Crystal River Unit 3
Docket No 50-302
Operating License No. DPR-72

Subject: Crystal River Unit 3 – Response to Request for Additional Information Re: Proposed License Amendment Request #270, Revision 0, “Power Uprate to 2568 MWt” (TAC No. MB5289)

**Response To Request For Additional Information Re: Proposed License
Amendment Request #270, Revision 0, Power Uprate to 2568 MWt**

Figure 1
Generator Reactive Capability Curve

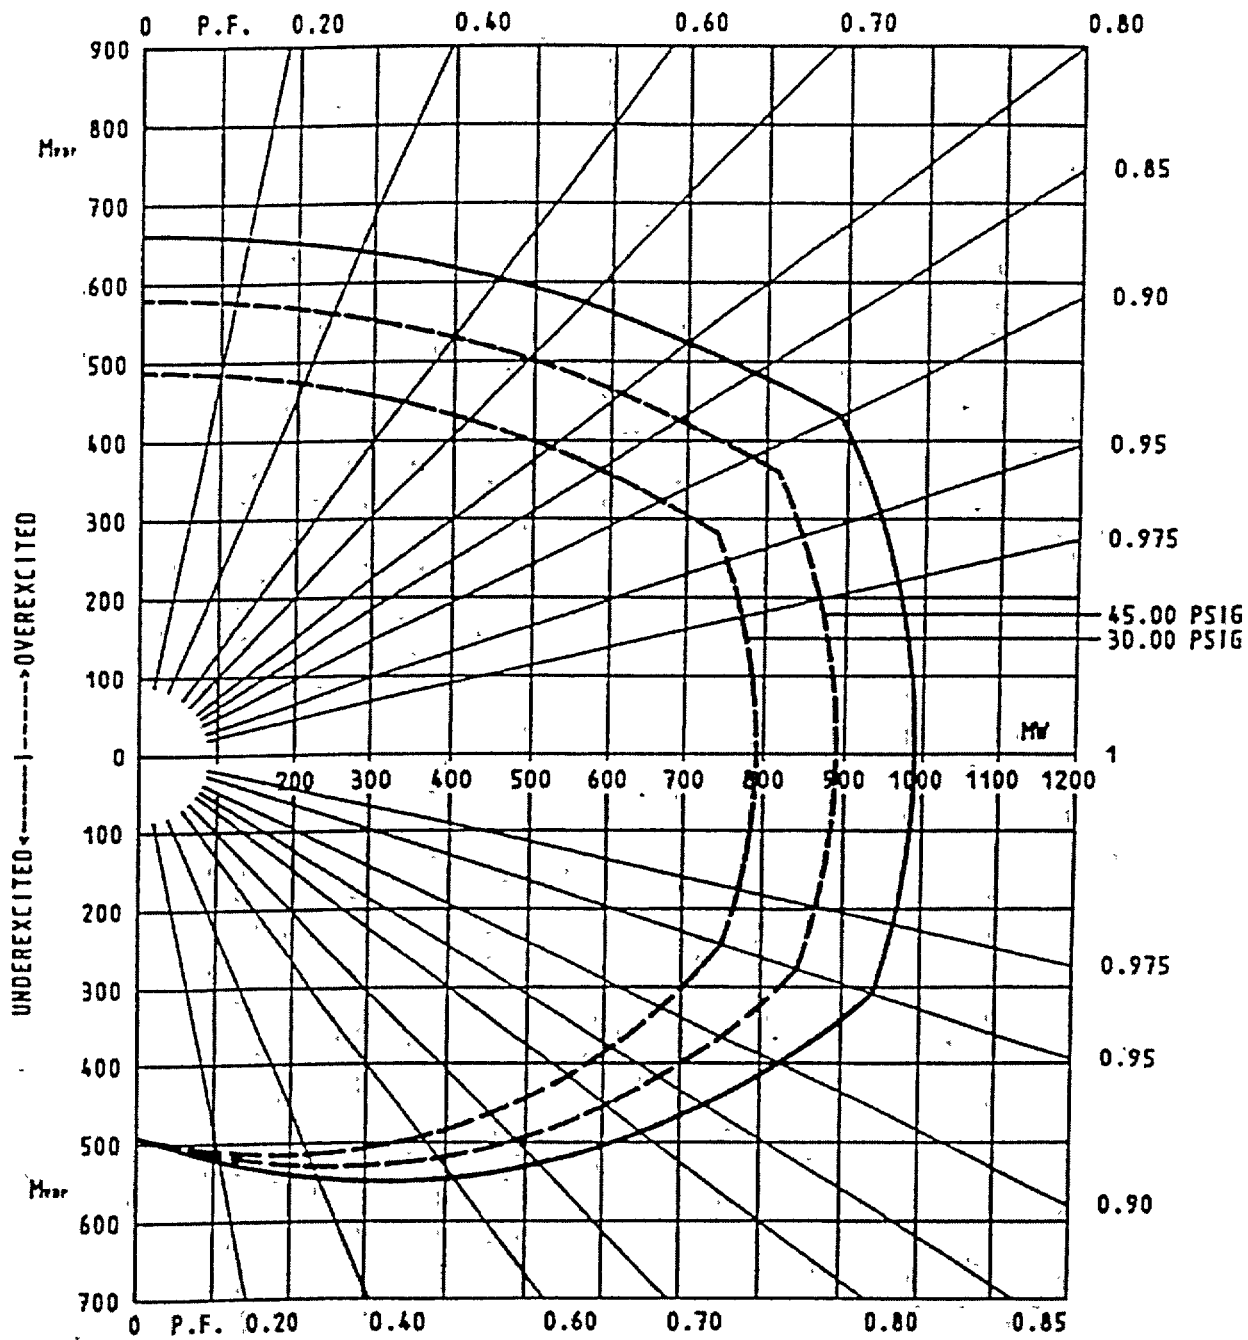
- 2. What impact will the power uprate have on the generator power factor? How will the uprate impact reactive load capability?**

Figure 1 shows the CR-3 generator Reactive Capability Curve. CR-3 will continue to operate within the limits of this curve after the power uprate. The CR-3 generator is capable of 989.4 MVA with a power factor of 1.0 (zero megavar output). With the current thermal power output, CR-3 can operate at approximately 895 MWe. The power uprate will enable CR-3 to operate at approximately 903 MWe. As MWe output is increased, the capability to carry reactive load decreases. CR-3 typically supplies between 50 to 250 megavars to the FPC grid. This small power uprate will not affect the ability of CR-3 to provide this reactive load.

CR-3's ability to carry reactive load is limited by the step up transformers and not the main generator. The step up transformers have a nominal rating of 950 MVA, lower than the main generator rating of 989.4 MVA. Operating at 903 MWe and a power factor of 0.95 would limit reactive load to approximately 295 megavars. This reactive load is greater than that generally required. If greater megavar output is needed, the MWe output would have to be decreased.

The power output values described assume a hydrogen cooling pressure of 60 psig. Lower hydrogen cooling pressure decreases generator capability. Note that the CR-3 generator is cooled by hydrogen only. The hydrogen is cooled by secondary cooling water. Section 4.9.1 of the original submittal incorrectly states that the hydrogen cooling is supplemented with cooling water for the stator.
